Affects: 9000 Series/D9412G-D7412G Operation and Installation Manuals

Figure 1: D8132 Battery Charger connection to a 9000 Series Panel

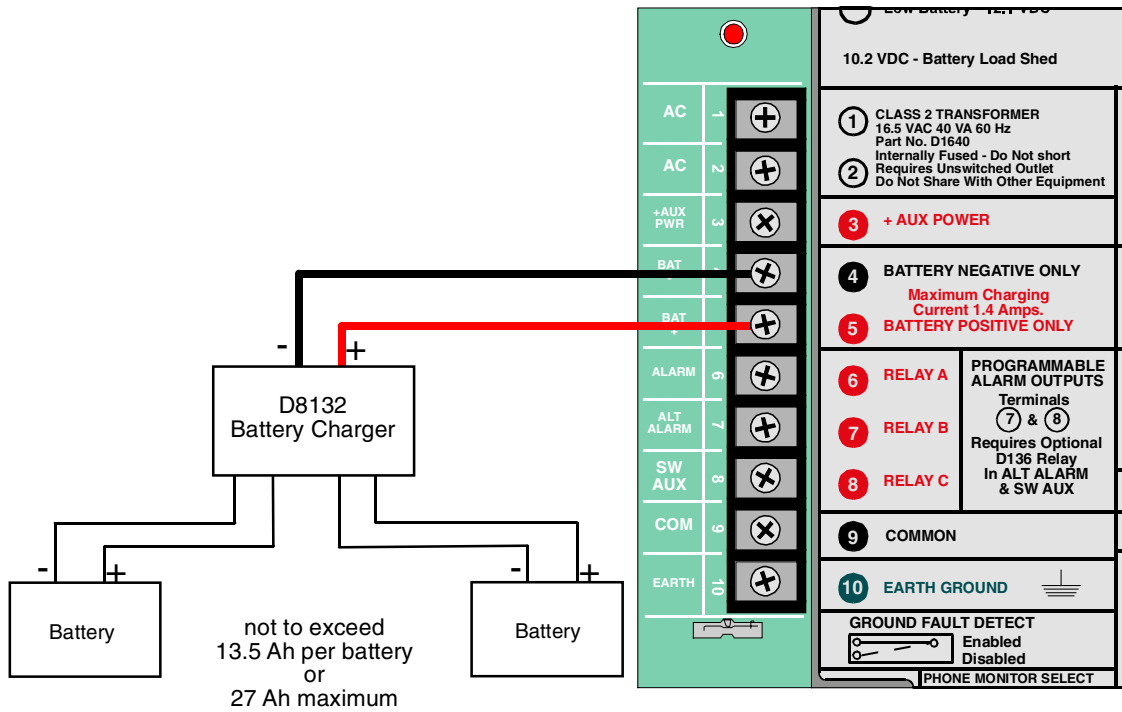
In the *9000 Series Operation and Installation Manual* (P/N: 74-07692-000) and the *D9412G/D7412G Operation and Installation Manual* (P/N: 43488D or earlier), Section 4.2.3 Replacing the Battery incorrectly states the battery support capacity of the D8132 Battery Charger as 36 Ah.

The correct capacity of the D8132 Battery Charger is 27 Ah.
